6 | Floorplans - Permitted and Proposed

Level B2 - Permitted

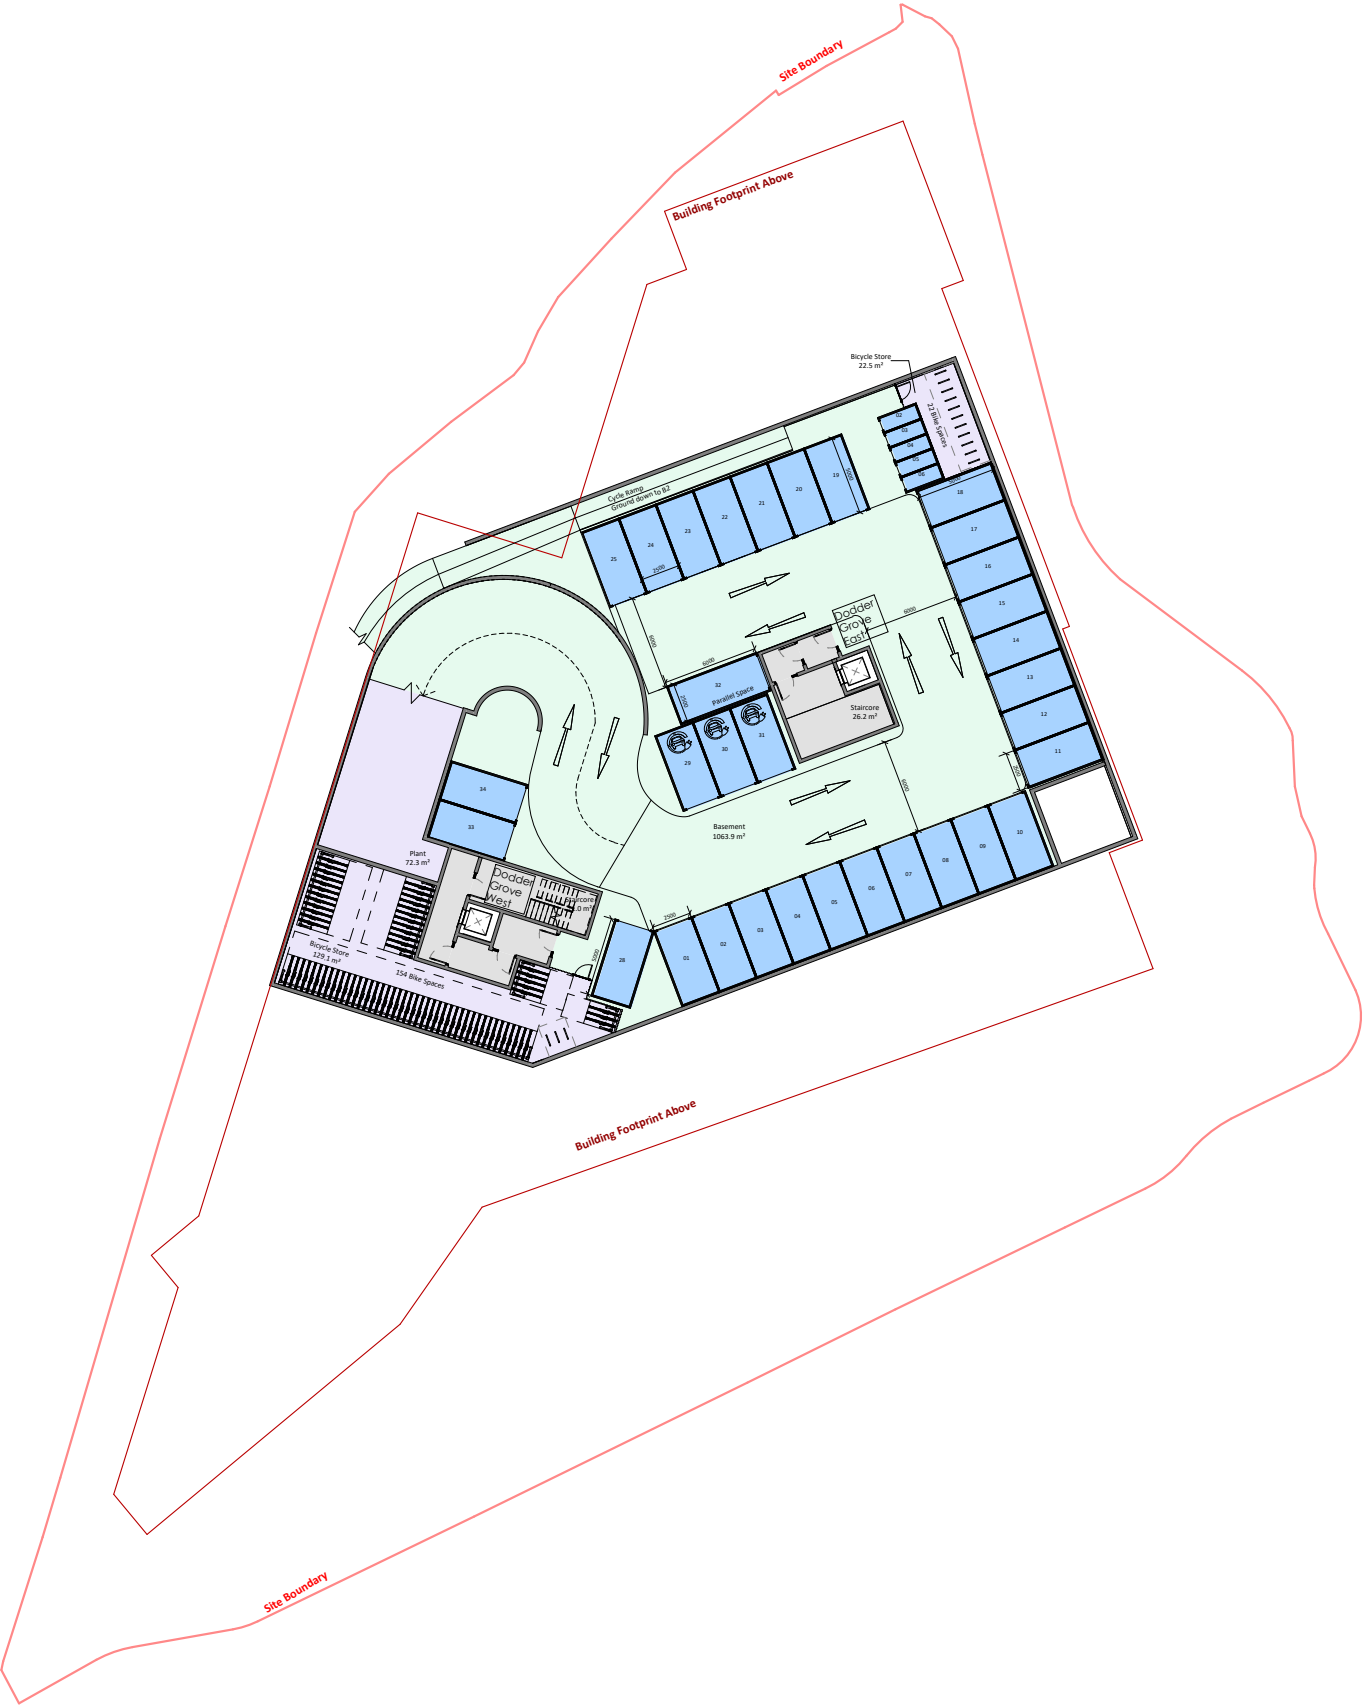
- Revised Core and Plant arrangements based on detail design including Fire / DAC strategy and M&E requirements
- Reconfiguration of car/motorbike parking layout
- Rationalization of Bicycle access route by removing the separate access ramp. Bicycle spaces reduced from 176no. to 149no. at level B2.
- Relocation of Plant and an uplift in plant area proposed
